AGENDA

Village of Chenequa Plan Commission
Monday, August 10, 2026, at 6:00 p.m.
31275 W. County Road K, Chenequa, WI 53029

Project Description: Proposed Stormwater Management Plan

Re: Stormwater Management Plan (SWMP) Review of 31795 West Muscovy Road
Drainage Improvements
Village of Chenequa, Wisconsin (Village)

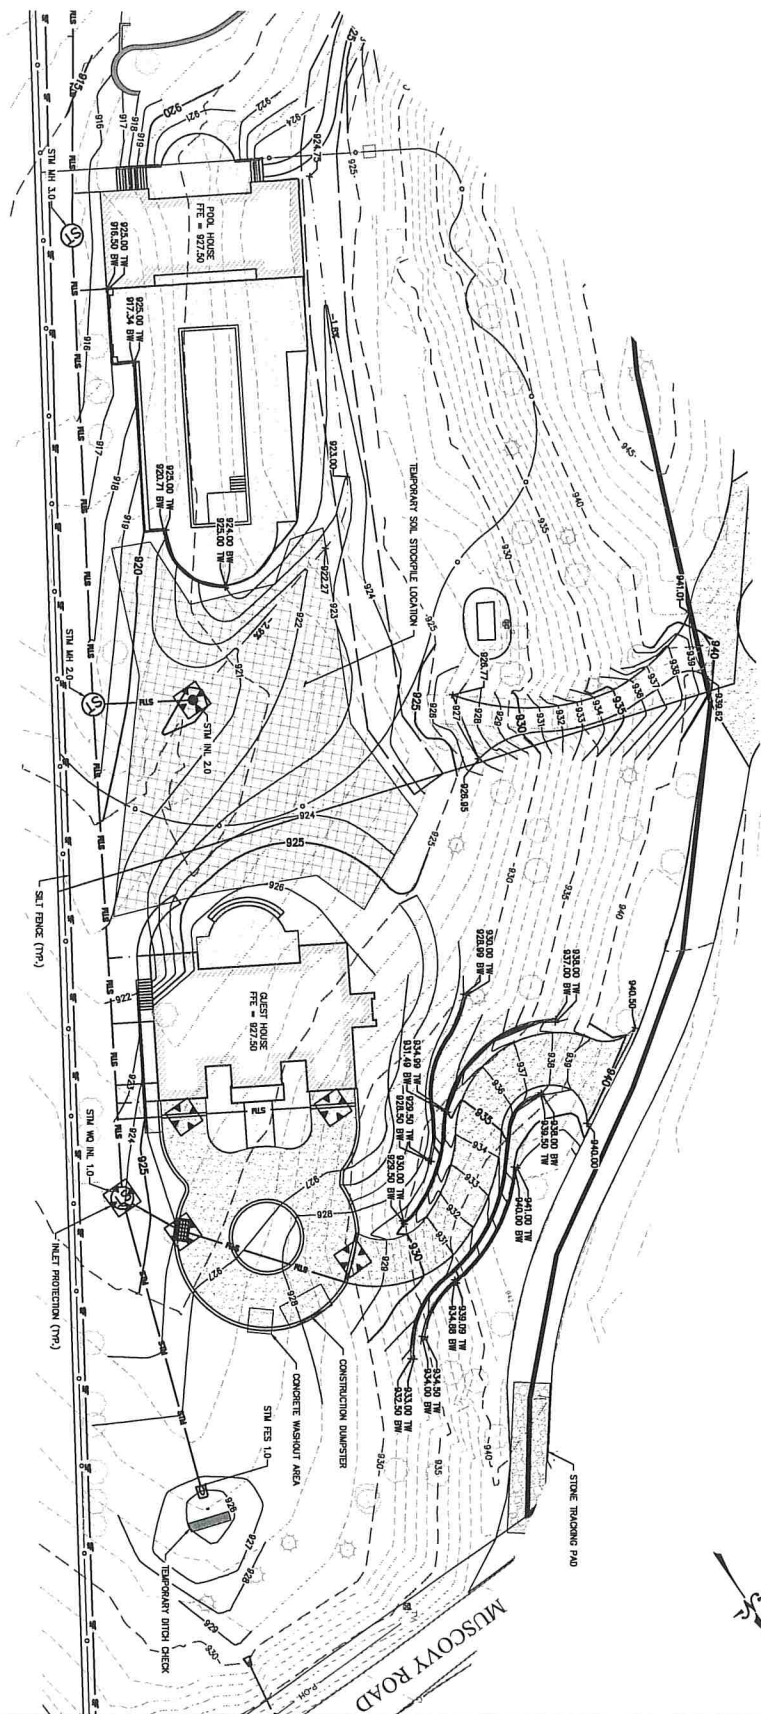
1. Grading & Erosion Control Plan—Sheet No. C300 and C301—Dated July 17, 2026.
2. Storm Sewer Plan & Profile—Sheet No. C200—Dated July 17, 2026.
3. Storm Water Management Plan—31795 West Muscovy Road—Dated July 23, 2026.
4. Soil Loss & Sediment Discharge Calculations—Dated July 9, 2026.
5. Lynch & Associates Engineering Consultants, LLC Response Letter—Dated July 9, 2026.

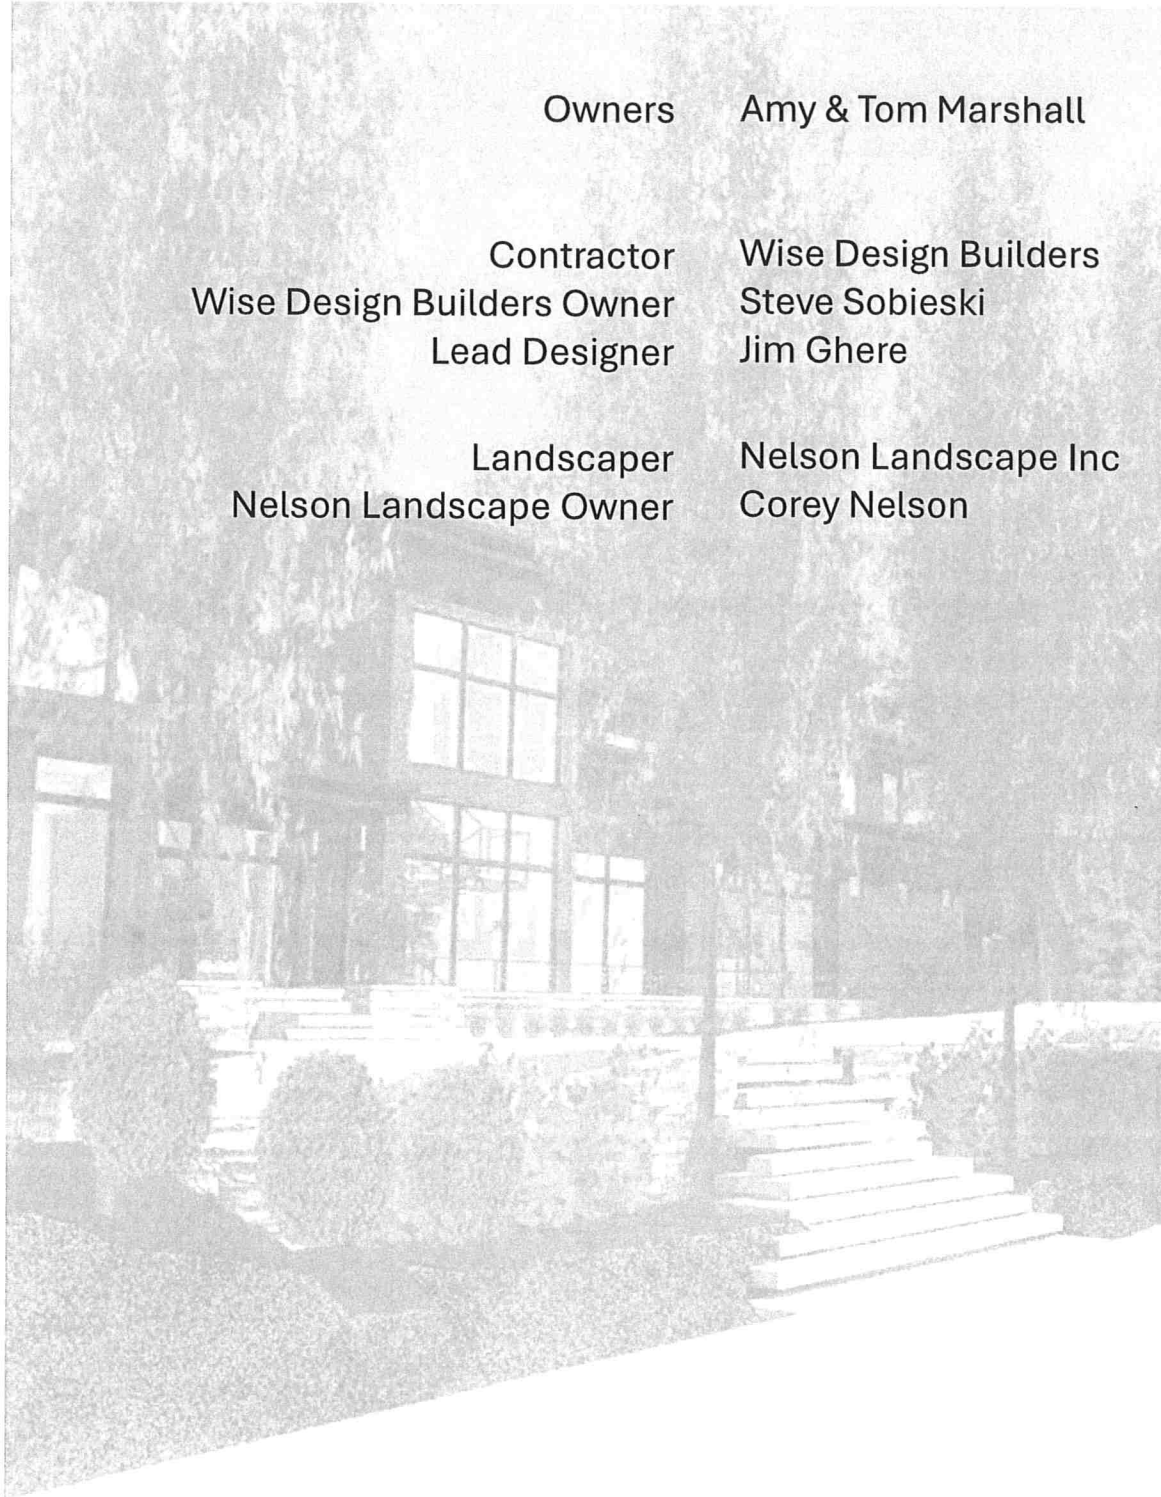
- a.) Around the proposed plantings, paths and patios the applicant proposes to install path and landscape lighting. These proposed lighting styles are both downward directed to reduce the possibility of light trespass and glare
 - a. These fixtures have a proposed color temperature of 2,700K and an output of 300-425 lumens
 - b. There are 56 path light in total proposed
- b.) Beneath hardscape step coping and along the proposed retaining walls, the applicants propose recessed rope lighting. As proposed, to eliminate the possibility for trespass and glare, this rope lighting is intended to illuminate downward and not outward

- a. These fixtures have a proposed color temperature of 2,700K and span a total of 490 linear feet
- b. These fixtures are 329 lumens per 16 linear feet
- c.) Near the outdoor kitchen there is some recessed lighting proposed. This lighting, as proposed will be recessed into the block and shielded to prevent outward directed light
 - a. These fixtures have a proposed color temperature of 2,700K and a lumen output of 200
 - b. There are 2 recessed lights proposed

Sheet #: L700 Page 8 of 10

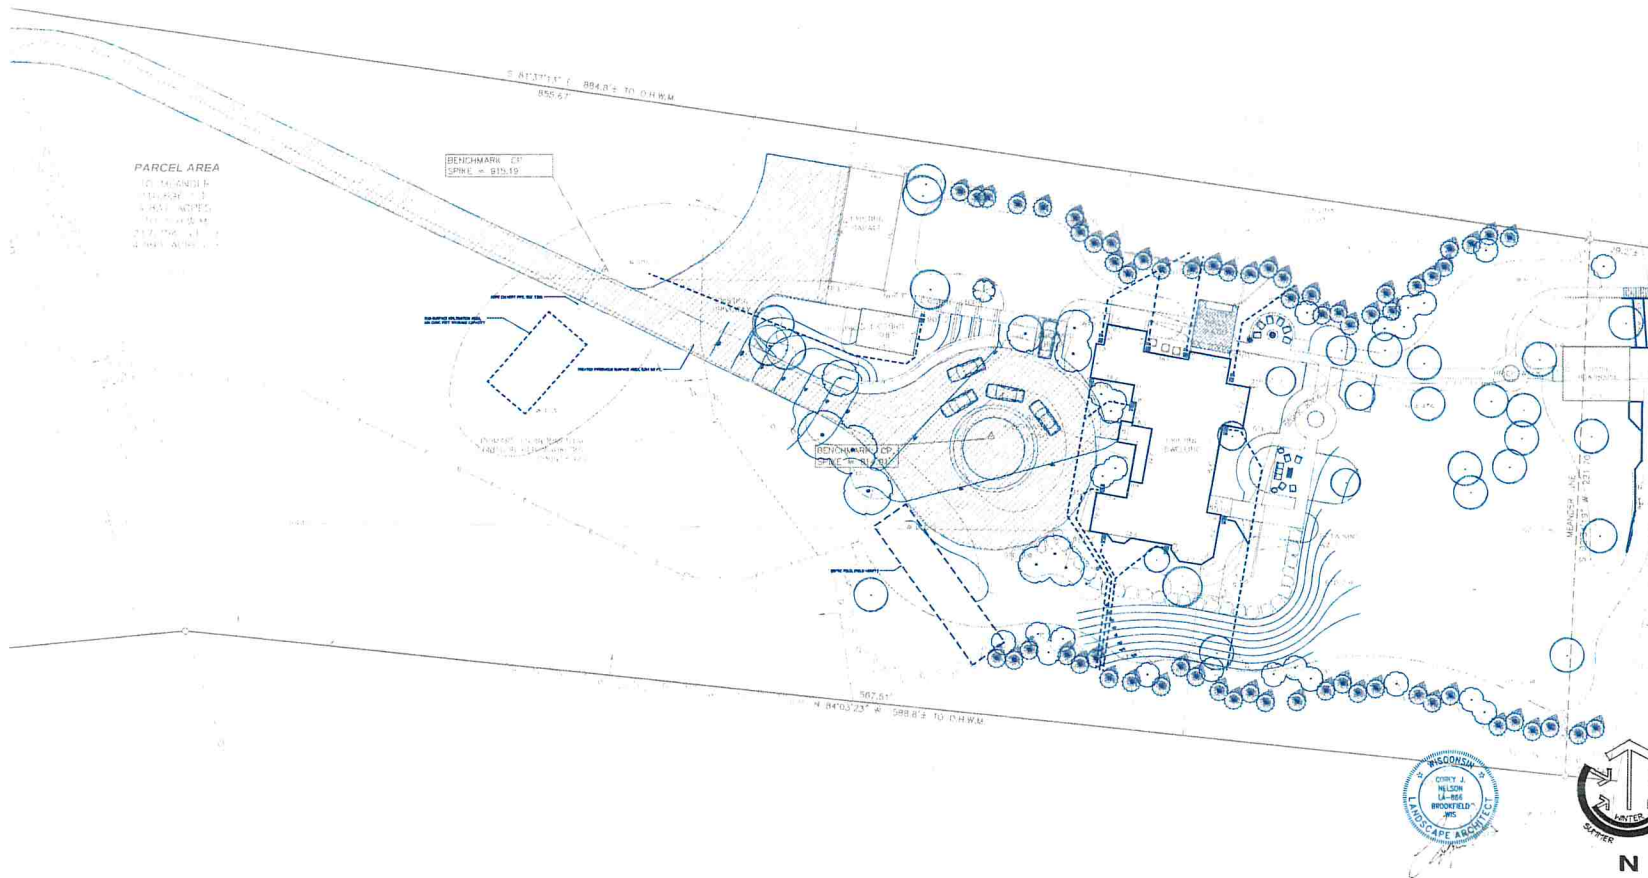
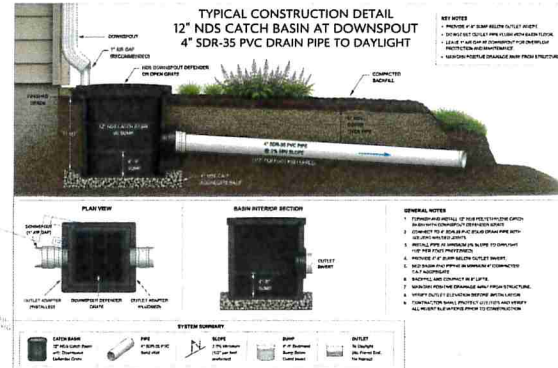
The submitted plans include a comprehensive landscape lighting plan consisting of:

- Tree-mounted downlights: The plans propose 16 tree mounted down lights approximately 15-20 feet above grade with an output of 425 lumens and a color temperature of 2,700 Kelvin.
 - These fixtures must be angled and mounted in a way to reduce the possibility of light trespass and glare onto neighboring properties.
- Pathway lighting: Approximately 44 pathway fixtures utilizing two fixture styles with an output of 425 lumens and a color temperature of 2700 Kelvin.
- Hardscape lighting: There are 14 hardscape lights in total. Two styles of recessed hardscape lighting incorporated into the proposed retaining walls and patios to provide downward-directed illumination with an output of 200 lumens and 425 lumens and a color temperature of 2700 Kelvin.
 - These fixtures must be angled and mounted in a way to reduce the possibility of light trespass and glare onto neighboring properties.
